Updates for CAST-2019

Gary Shenk - CBPO

The approved nitrogen fixation rate for “other haylage; grass silage and greenchop” is inadvertently high

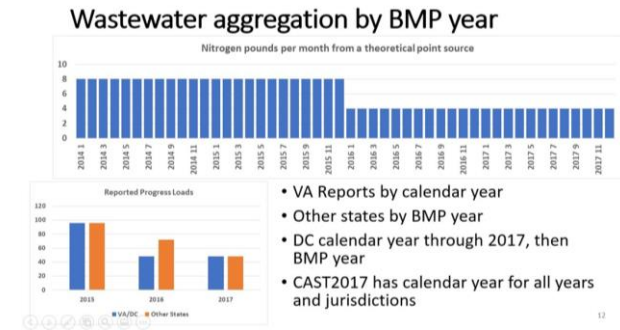
- **Issue:** An incorrect, and high, value for the crop “other haylage; grass silage and greenchop” was inadvertently put in the list of values to be approved by the AMS and AgWG. The values were approved without anyone noticing the error.
- **Action:** On Sept 19th, the AgWG will consider for approval a new value to be used in CAST for all scenarios.
- **Effect:** This crop type was first seen late in the 2002 Ag Census. The high value of fixation is creating high nitrogen loads relative to earlier periods without this crop. The new fixation rate will reduce total delivered N loads by approximately 0.7 million pounds in the 2018 progress run
- **Rationale:** This crop type had zero acres in 1995 so there would be no change to the loads during the TMDL critical period. The update is a more accurate representation.

Wastewater aggregation by BMP year

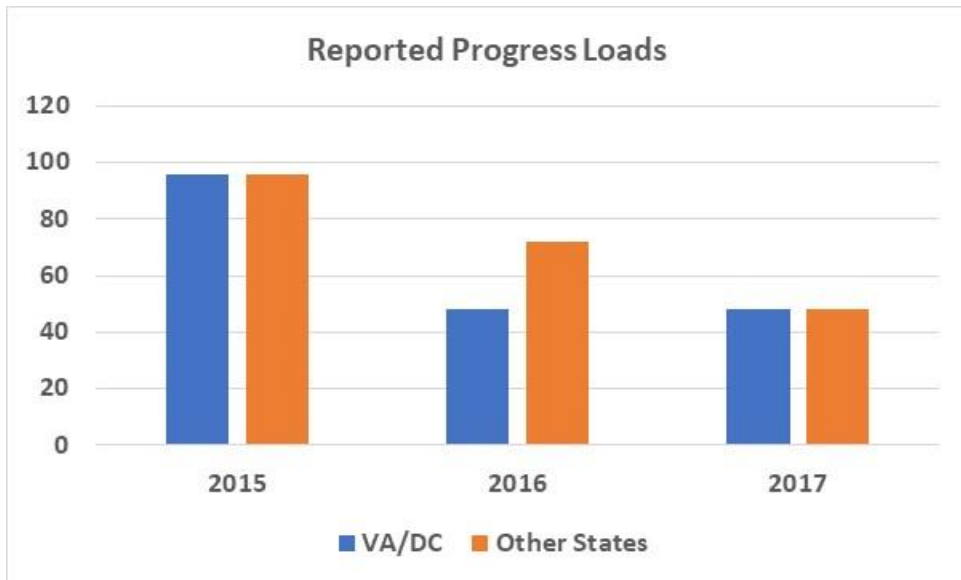
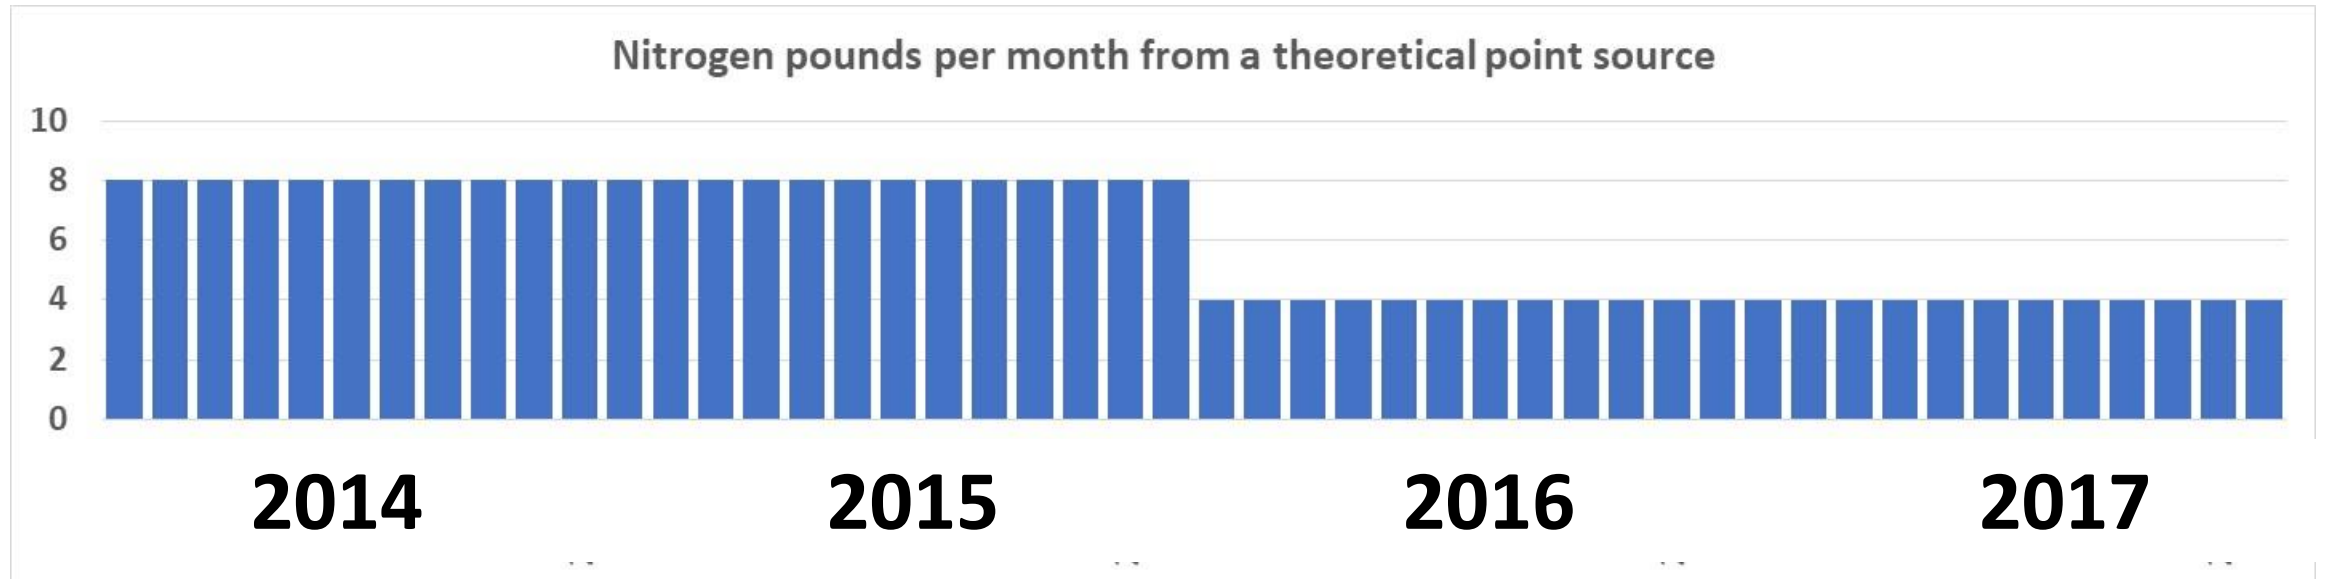
- **Issue:** Wastewater data is supposed to be aggregated by calendar year for VA in all years and DC through 2017. For all other jurisdictions and in DC after 2018, wastewater is supposed to be aggregated by BMP year (July through June). Wastewater is currently aggregated by calendar year for all jurisdictions for progress scenarios.
- **Action:** Recalculate wastewater for progress years.
- **Effect:** Increase in loads for progress years in which upgrades occurred in the second half of the year. No effect on WIPs.
- **Rationale:** The change does not affect the calibration run, which is the base for the TMDL critical period.

Add Biofilters BMP

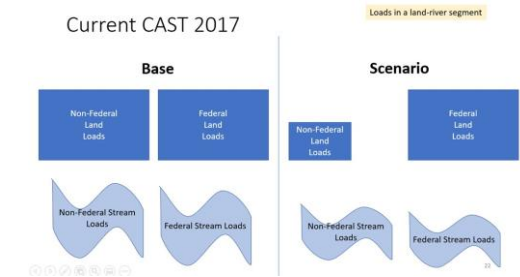
- **Issue:** Biofilters are an approved BMP but they are not credited properly in the model and have never been. None have been submitted through NEIEN.
- **Action:** Add biofilters as a BMP
- **Effect:** Future scenarios will include biofilters. Will reduce loads in some WIP scenarios
- **Rationale:** Adding an approved BMP
- ***As with all BMPs, implementation prior to the critical period will not be counted***

Stream response to upstream load should be proportional to load change by LRseg and agency rather than just LRseg

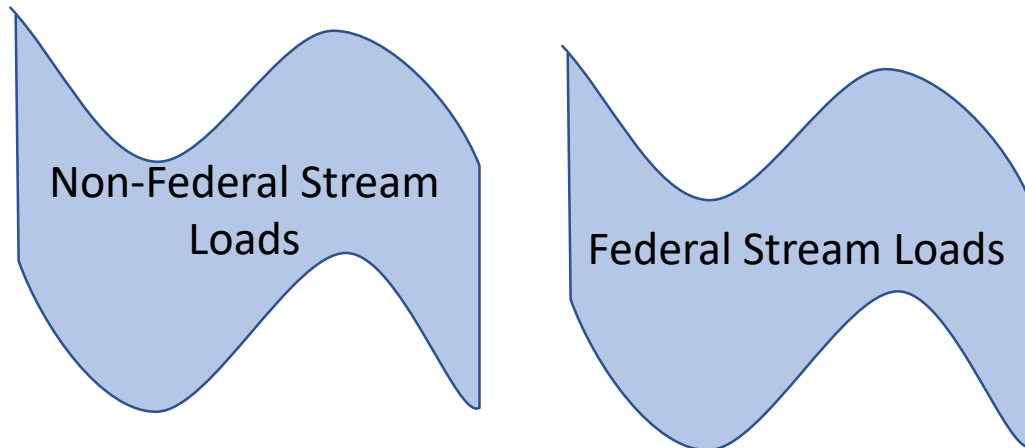
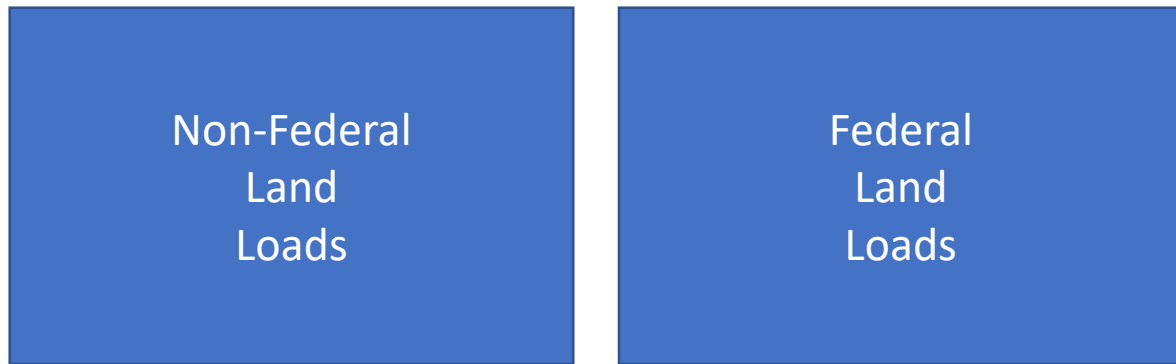
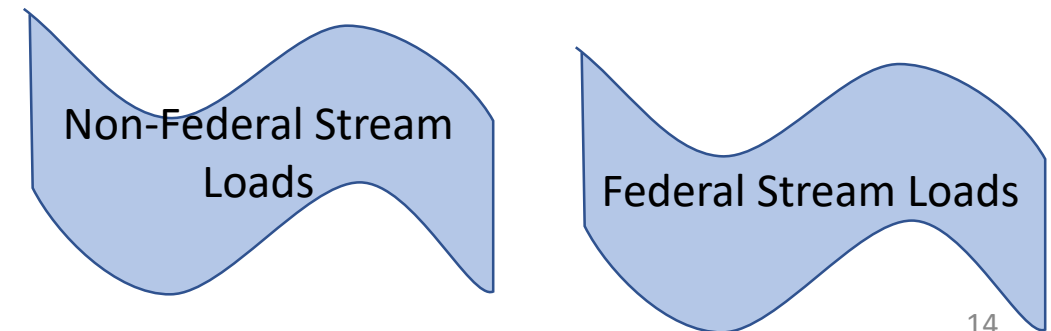
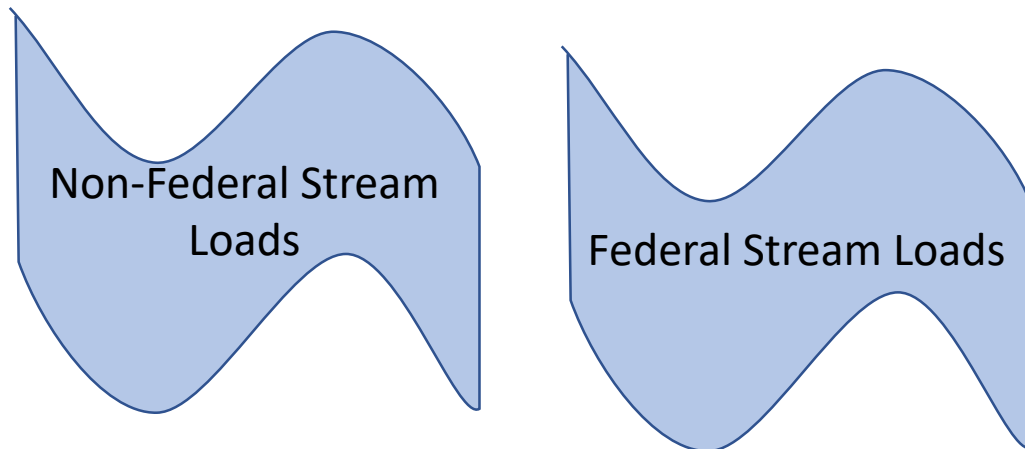
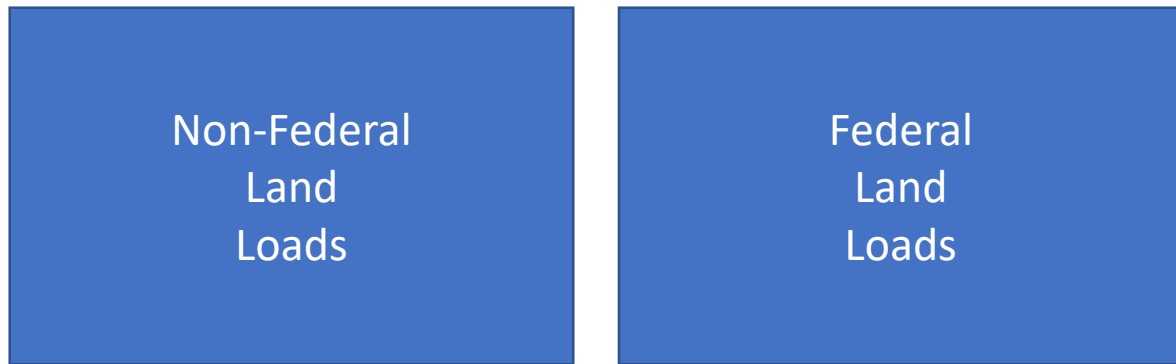
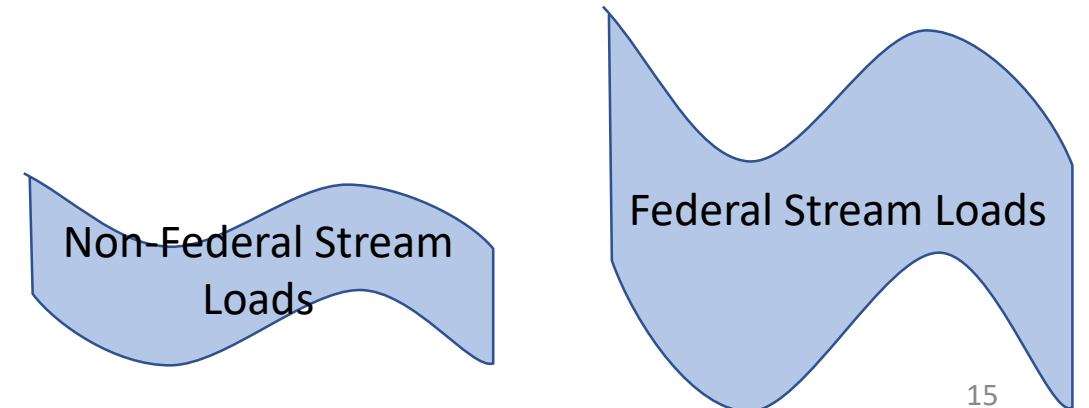
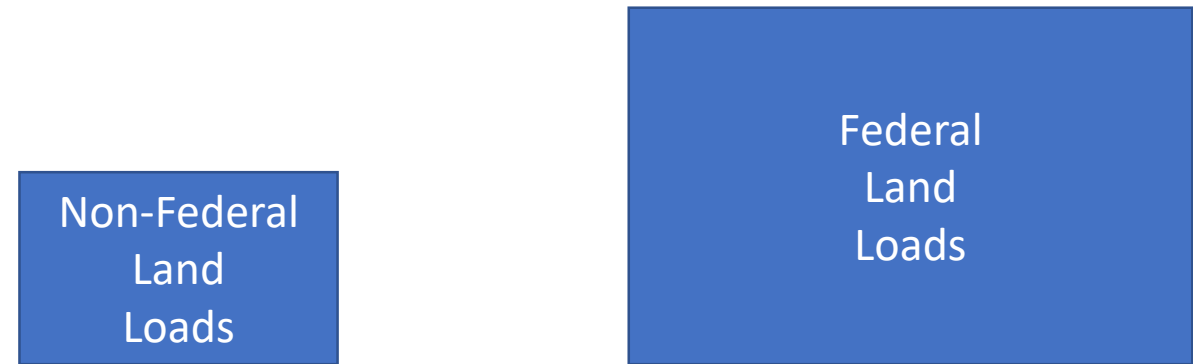
- **Issue:** Stream bed and bank loads change through scenarios proportional to upstream loads. This is currently calculated by percent change in the land-river segment load. Using this method, the stream bed and bank load attributed to a federal agency changes when a scenario is run with changes in the non-federal portion. This causes confusion similarly to the changing delivery factors in the pre-TMDL Phase 5 model.

- **Action:** Stream bed and bank loads will be calculated by LRseg and agency.
- **Effect:** scenarios for a given agency will be more consistent. No changes in delivered overall loads from LRseg, load sources, or agencies. Small changes in total LRseg stream loads for scenarios based on spatial differences in delivery factors.

- **Rationale:** Dividing up stream bed and bank loads in a way more consistent with management needs. No change in calibration loads for the TMDL critical period
